[Docket No. 96-CE-09-AD; Amendment 39-9872; AD 97-01-01]

Airworthiness Directives; The New Piper Aircraft, Inc. PA24, PA28R, PA30, PA32R, PA34, and PA39 Series Airplanes

ACTION: Final rule.

Figure 1

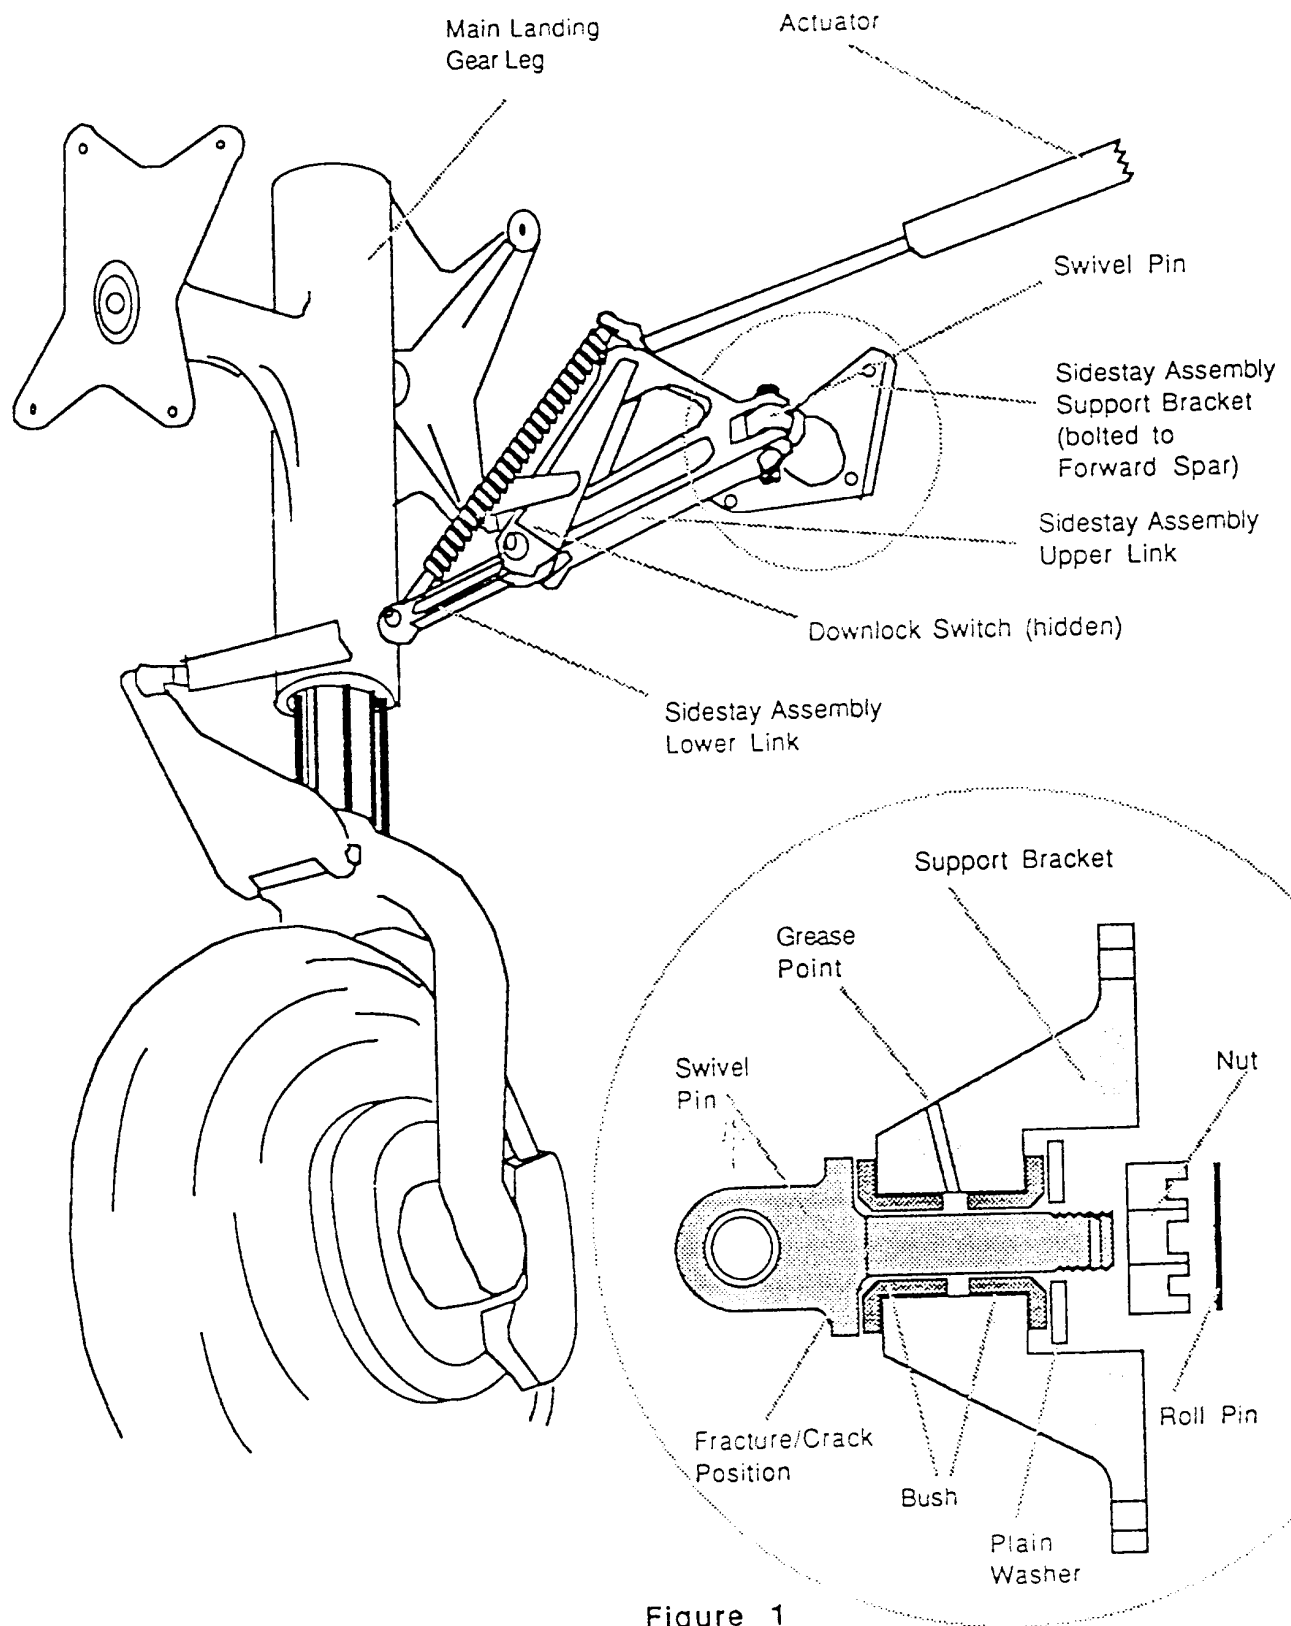
(a) Remove both the left and right main gear sidebrace studs from the airplane in accordance with the instructions contained in the Landing Gear section of the maintenance manual, and inspect each main gear sidebrace stud for cracks, using Type I (fluorescent) liquid penetrant or magnetic particle inspection methods. Figure 1 of this AD depicts the area of the sidebrace stud shank where the sidebrace stud is to be inspected.
